**VALUE ENGINEERING STUDY
OF
RECONSTRUCTION OF I-64/
KY 180 INTERCHANGE
Item Number: 9-60.00**

**Boyd County, Kentucky
October 17-21, 2005**

**Prepared by:
VENTRY ENGINEERING, L.L.C.**

**In Association With:
KENTUCKY TRANSPORTATION CABINET**

VE
RAMP A

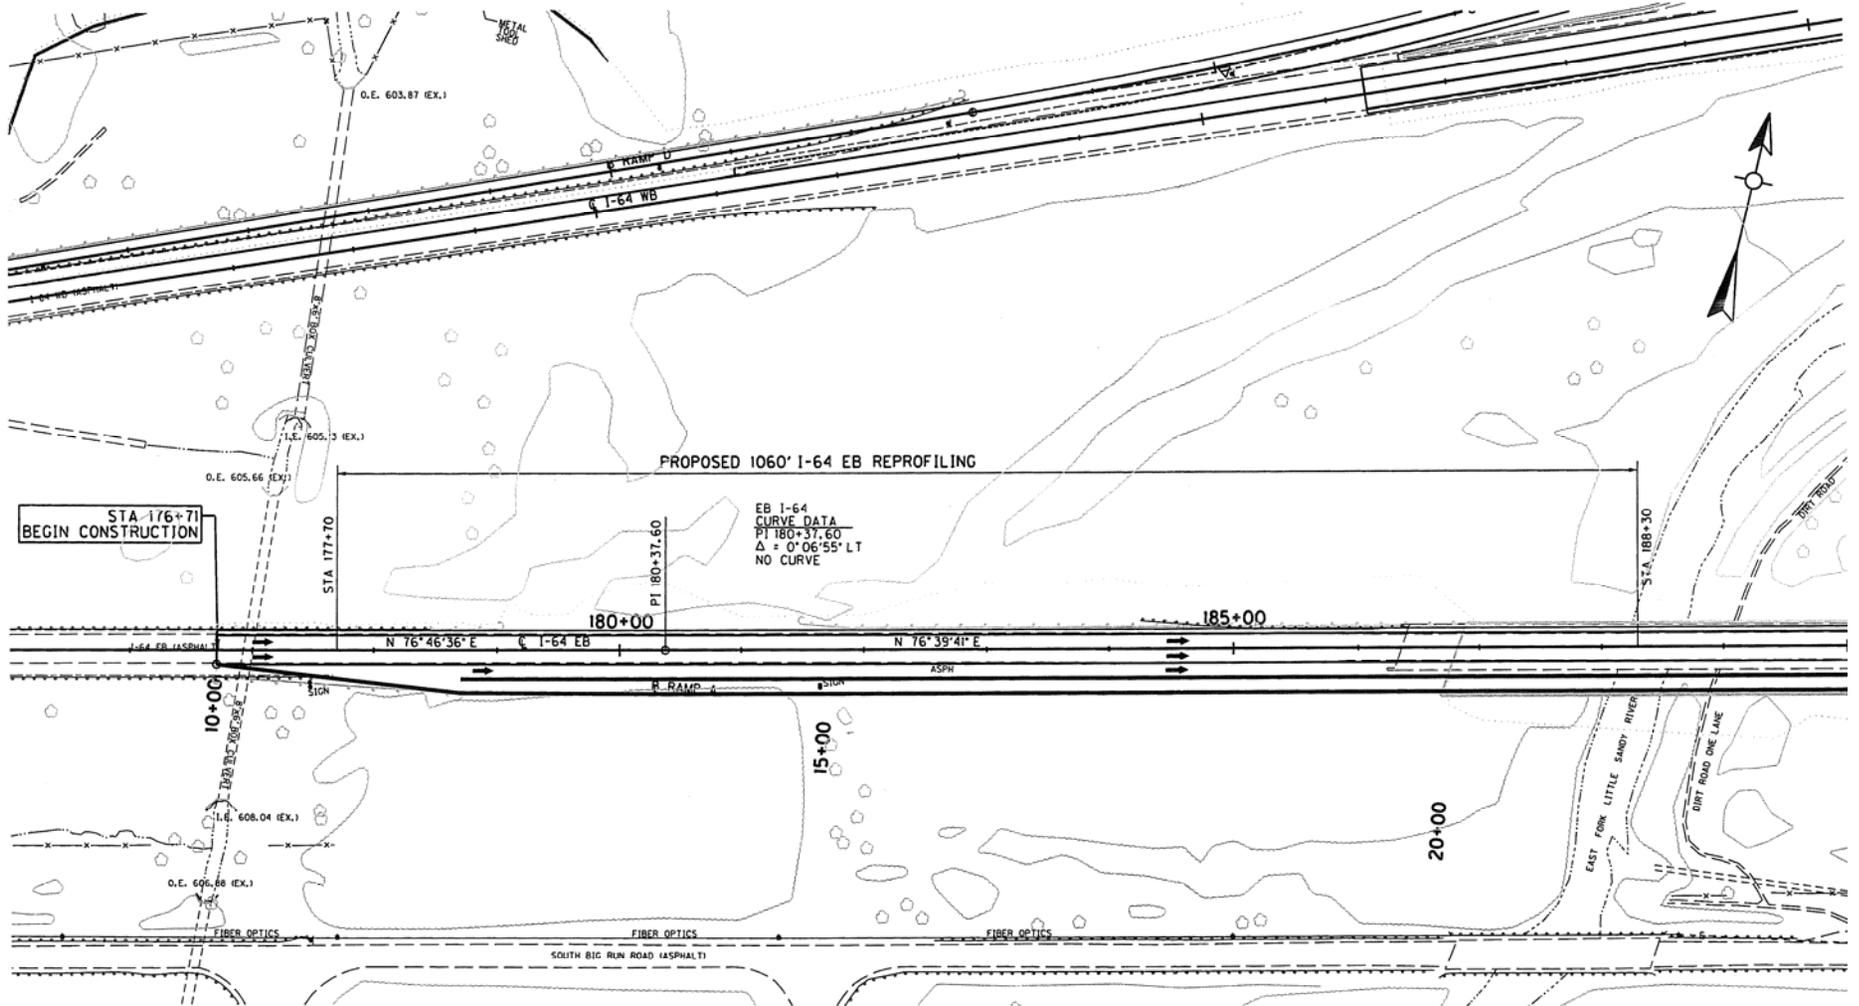
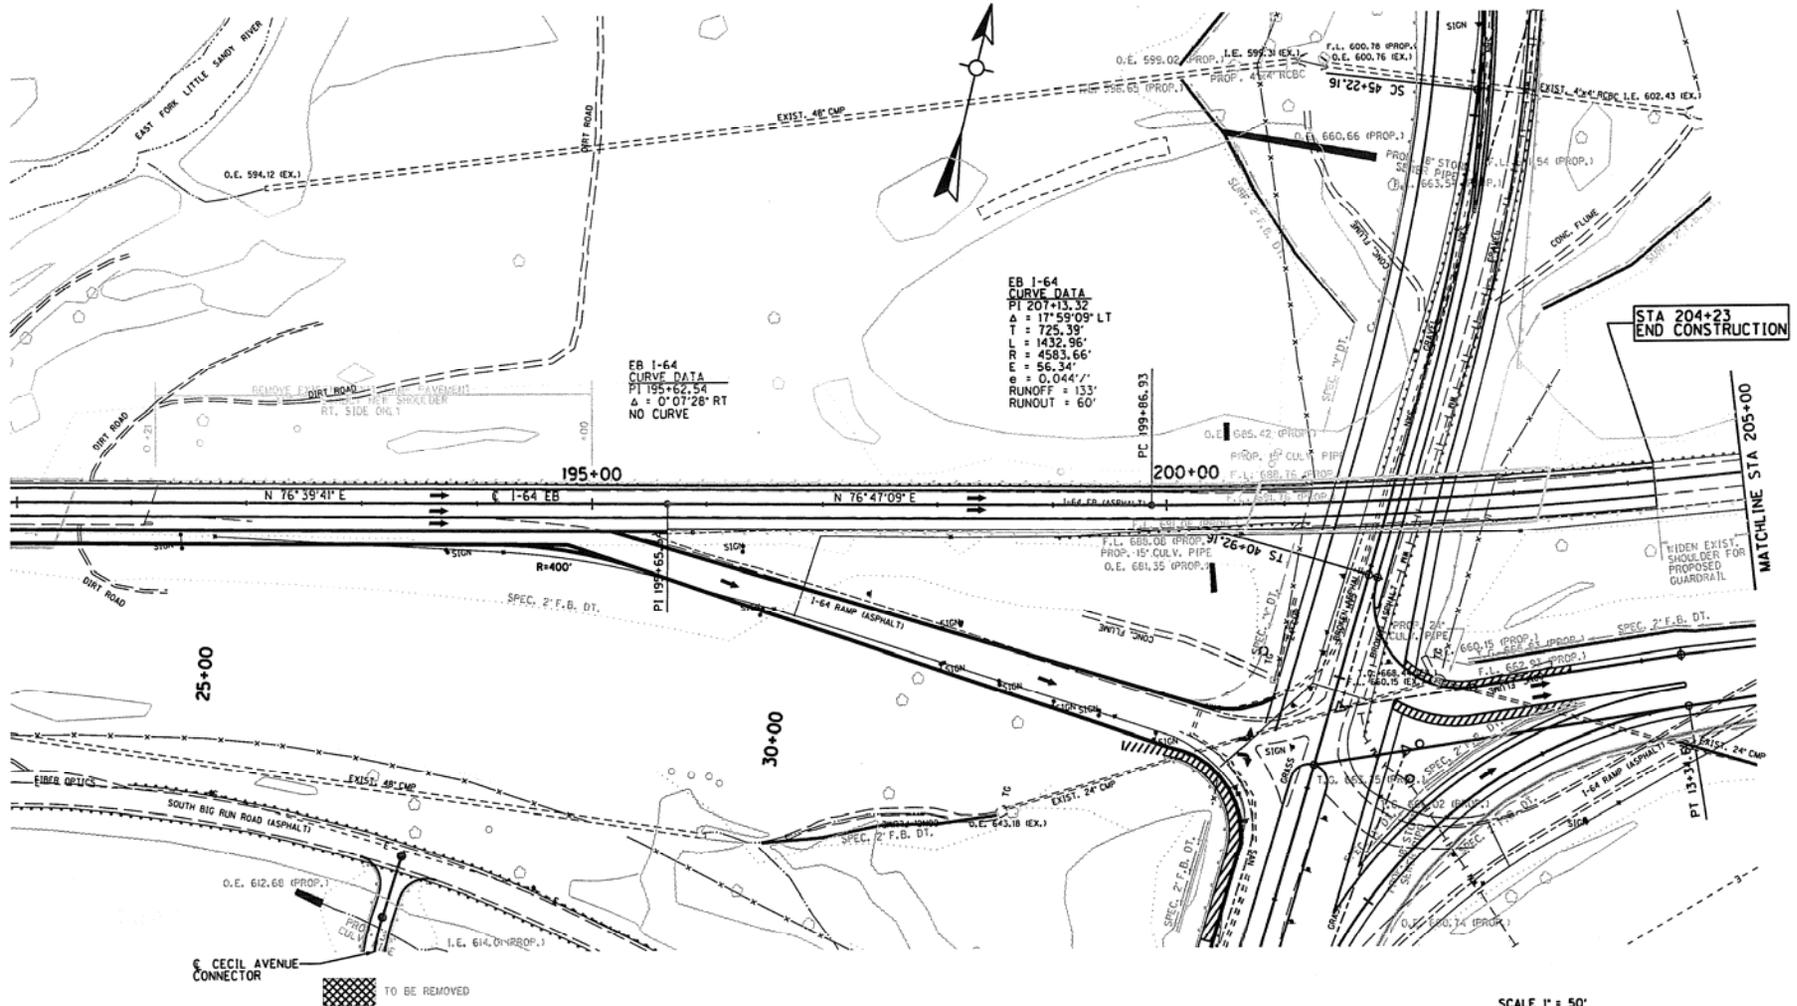
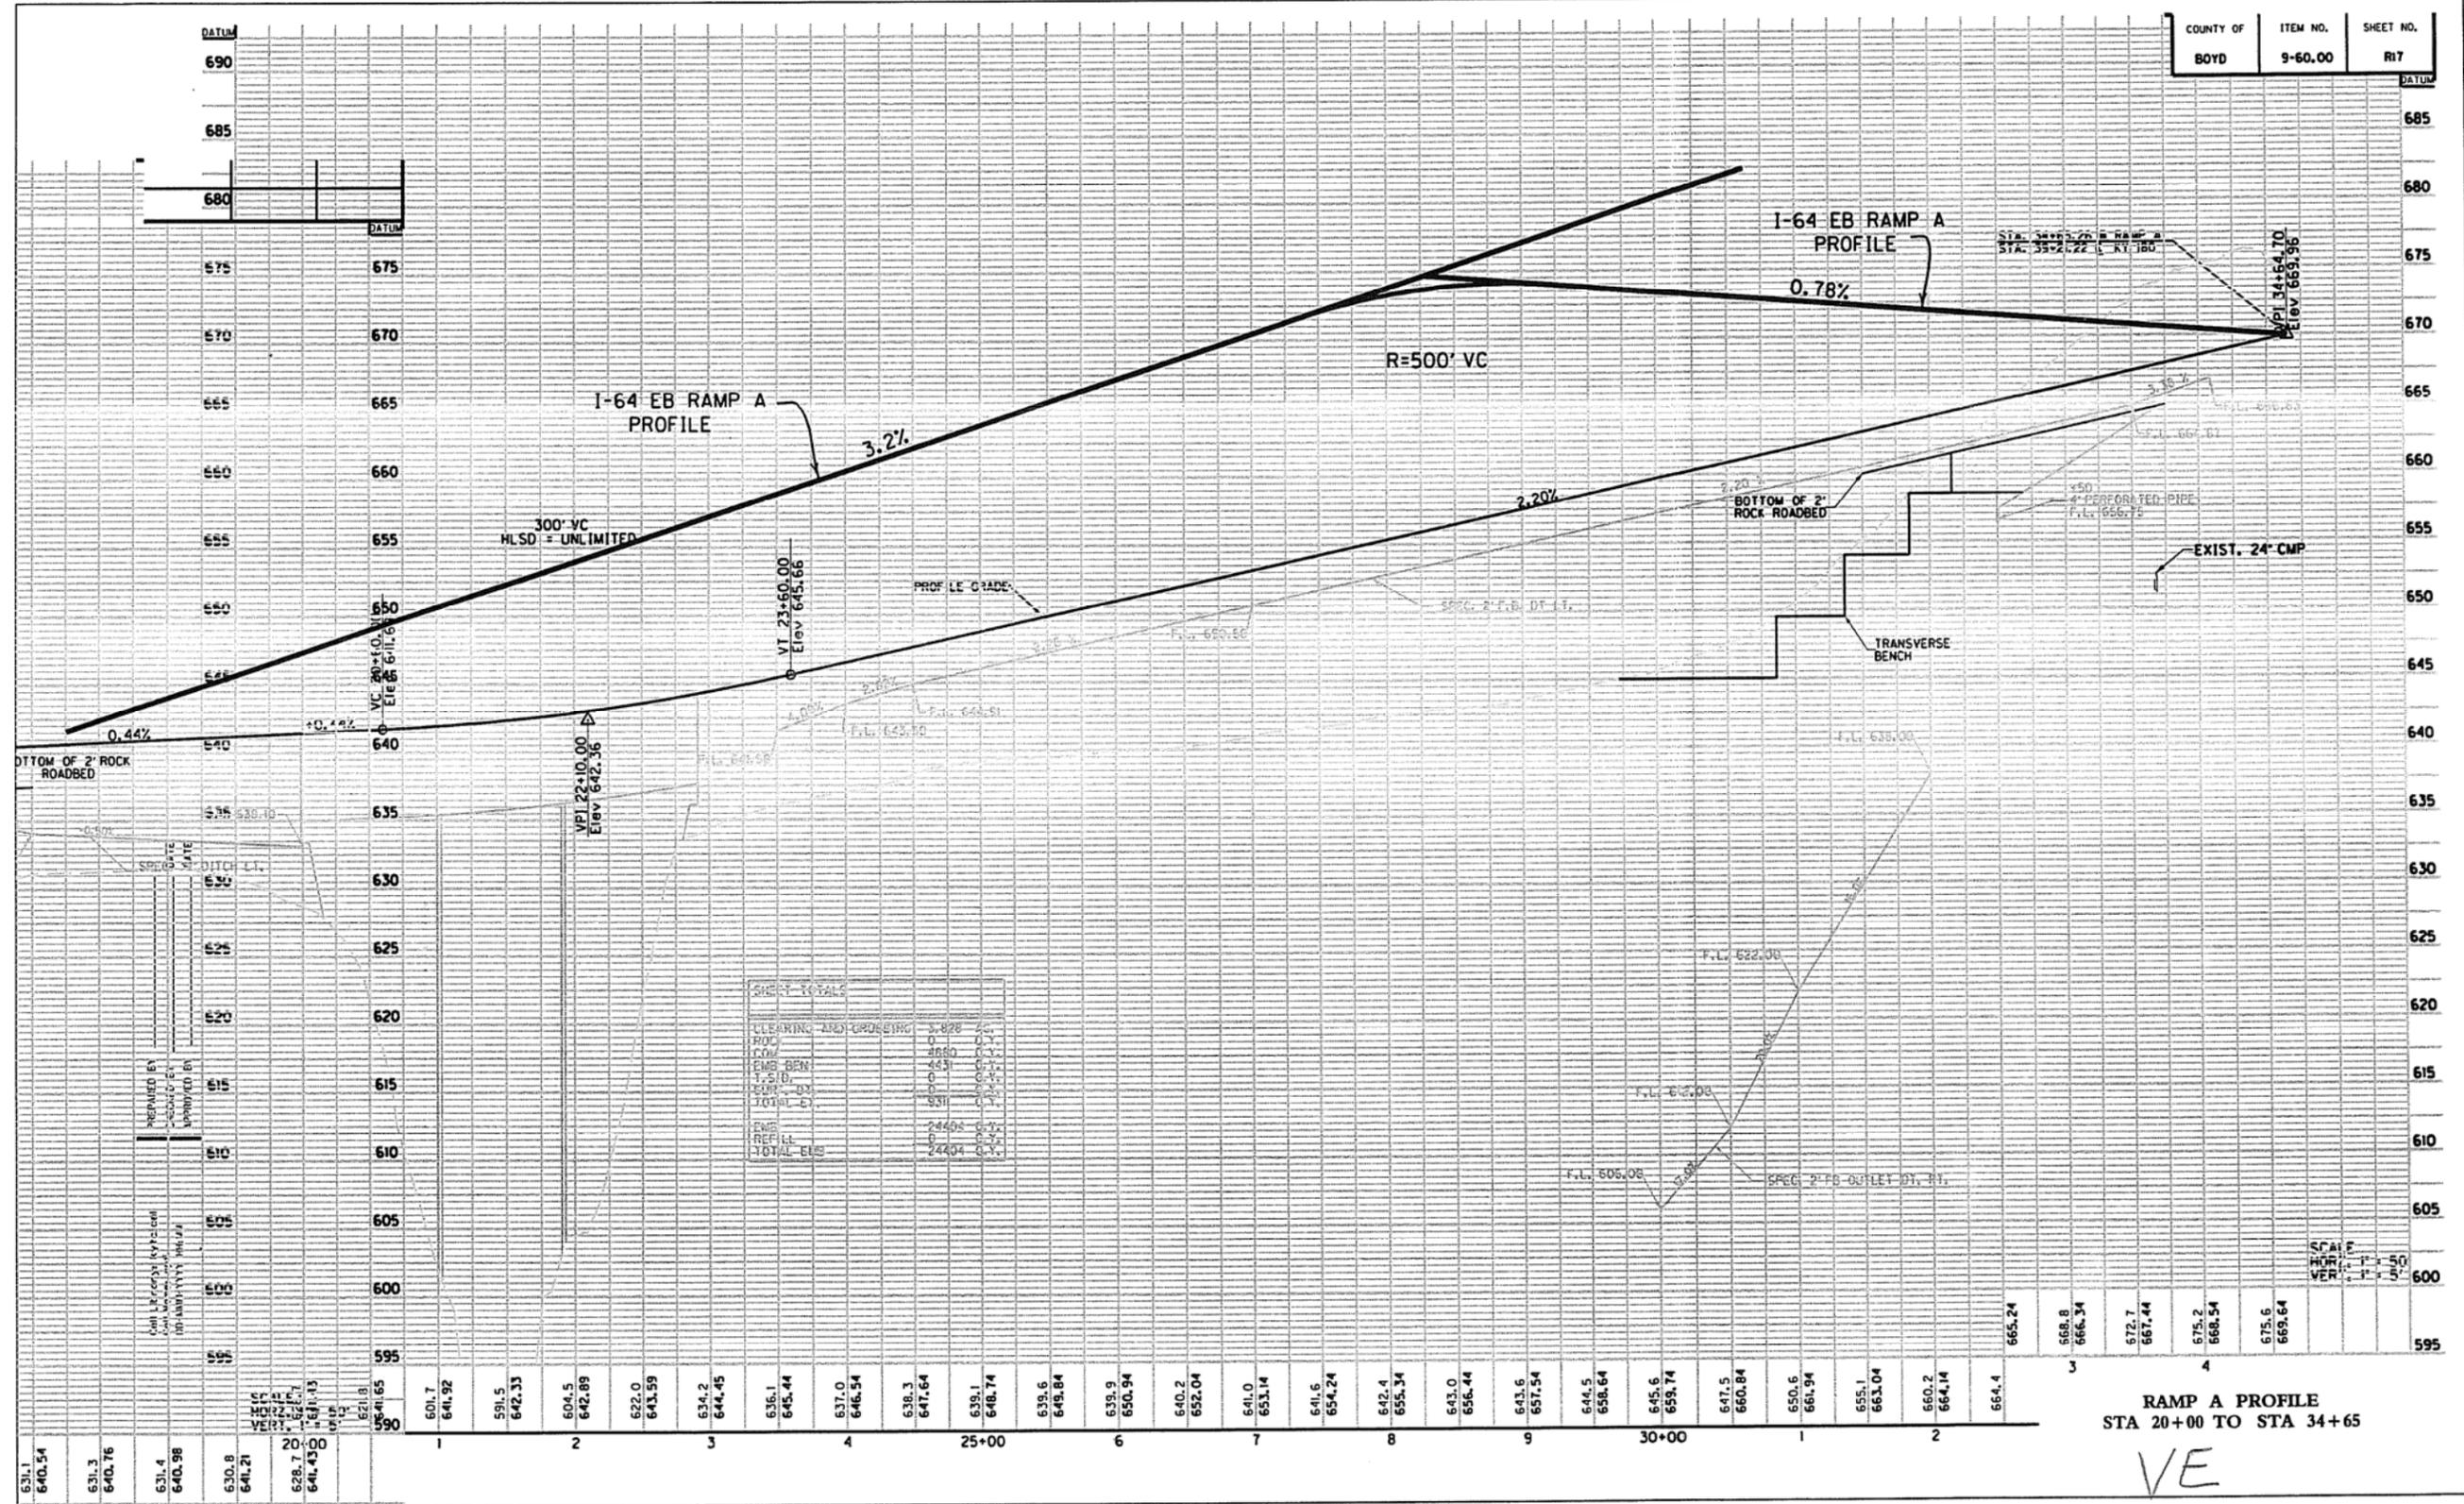
The VE team recommends that the intersection of the A and D ramps with KY180 be modified to provide a better operating intersection in closer conformity with Kentucky's desired intersection criteria. The VE team believes that desirable intersection criteria should control over open road criteria at a major signalized intersection.
